Groundwater and Wastewater Services File Imaging Project

Mecklenburg County
Health Department

RE: Property located at 9724 Shopton Road, W.
FILE: 4381A
PARCEL: 19923103 PO

CKLENBURG COUNTY ENVIRONMENTAL HEALTH
TE EVALUATION REPORT
ERIAL NUMBER 11989

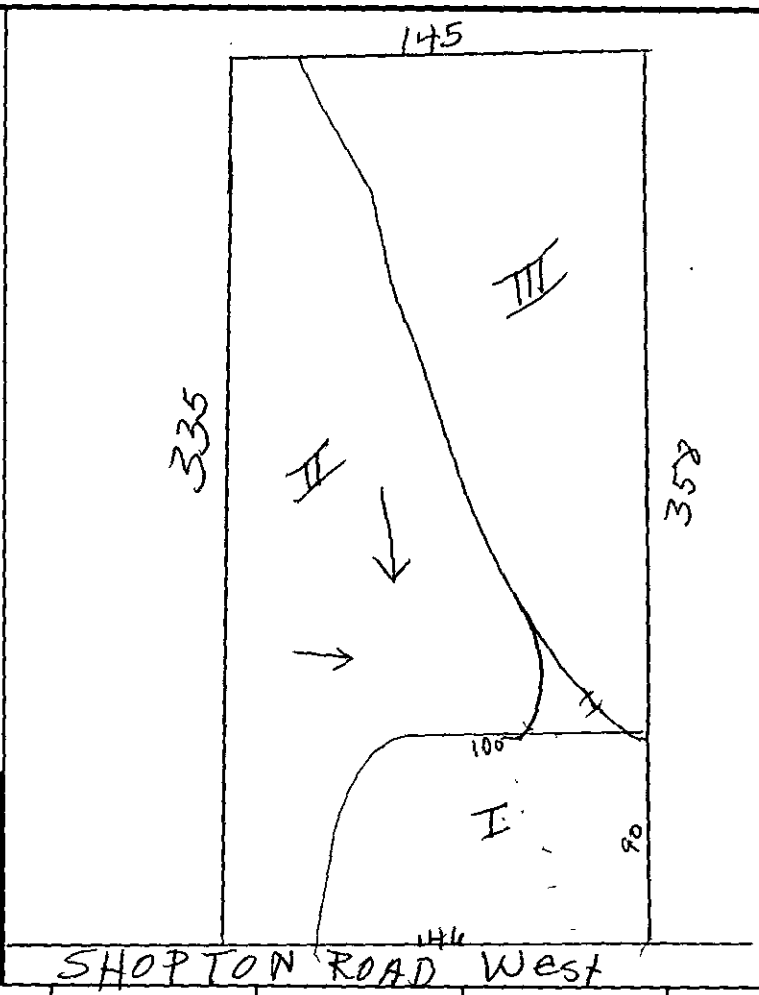
Comments: CAN Reach This Area by Gravity

FACTORS	AREA 1	AREA 2	AREA 3	AREA 4	AREA 5	AREA 6
Topography	S (PS) U 2-4	S (PS) U 0-2	S (PS) U 2-4	S PS U	S PS U	S PS U
Texture	S (PS) U	S (PS) U	S (PS) U	S PS U	S PS U	S PS U
Structure	S (PS) U	S (PS) U	S (PS) U	S PS U	S PS U	S PS U
Drainage	S (PS) U	S PS (U)	S (PS) U	S PS U	S PS U	S PS U
Depth	S (PS) U 36-39	S PS (U) 16-26"	S PS (U) 34-35	S PS U	S PS U	S PS U
Restrictive Horizons	S (PS) U	S (PS) U	S (PS) U	S PS U	S PS U	S PS U
Available Space	S (PS) U	S (PS) U	S (PS) U	S PS U	S PS U	S PS U
Other (specify)	S PS U	S PS U	S PS U	S PS U	S PS U	S PS U
Soil Group/Series	IVa DAVIDSON Except Depth	IVa Cullen-Davidson	IVa Cullen Davidson			
Area Classification	S (PS) U	S PS (U)	S PS (U)	S PS U	S PS U	S PS U

MECKLENBURG COUNTY ENVIRONMENTAL HEALTH
SITE EVALUATION REPORT
SERIAL NUMBER 15084

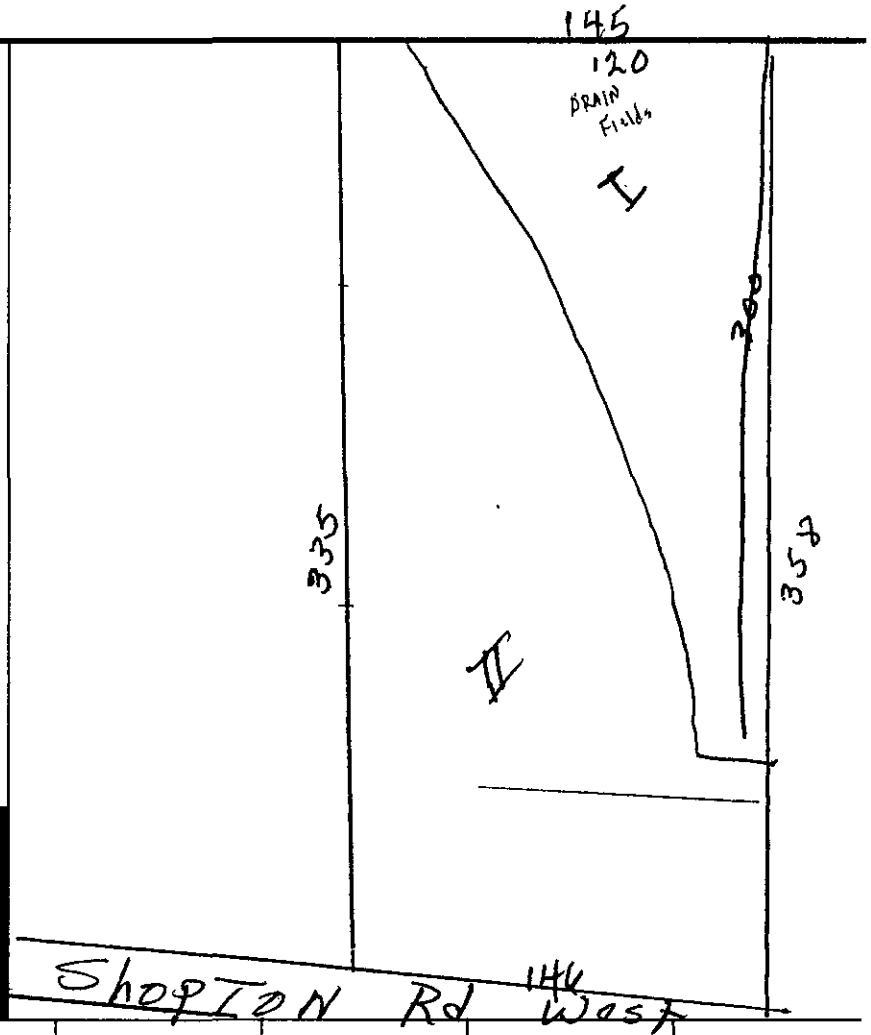
Comments: Lift Station Required

FACTORS	AREA 1	AREA 2	AREA 3	AREA 4	AREA 5	AREA 6
Topography	S (PS) U 2-4	S (PS) U 0-2	S PS U	S PS U	S PS U	S PS U
Texture	S (PS) U	S (PS) U	S PS U	S PS U	S PS U	S PS U
Structure	S (PS) U	S (PS) U	S PS U	S PS U	S PS U	S PS U
Drainage	S (PS) U	S PS (U) LOW	S PS U	S PS U	S PS U	S PS U
Depth	S PS (U) 35-34	S PS (U) 26-16"	S PS U	S PS U	S PS U	S PS U
Restrictive Horizons	S (PS) U	S (PS) U	S PS U	S PS U	S PS U	S PS U
Available Space	S (PS) U	S (PS) U	S PS U	S PS U	S PS U	S PS U
Other (specify)	S PS U	S PS U	S PS U	S PS U	S PS U	S PS U
Soil Group/Series	IIa Mixed Series	~~IIa~~				
Area Classification	S PS (U)	S PS (U)	S PS U	S PS U	S PS U	S PS U
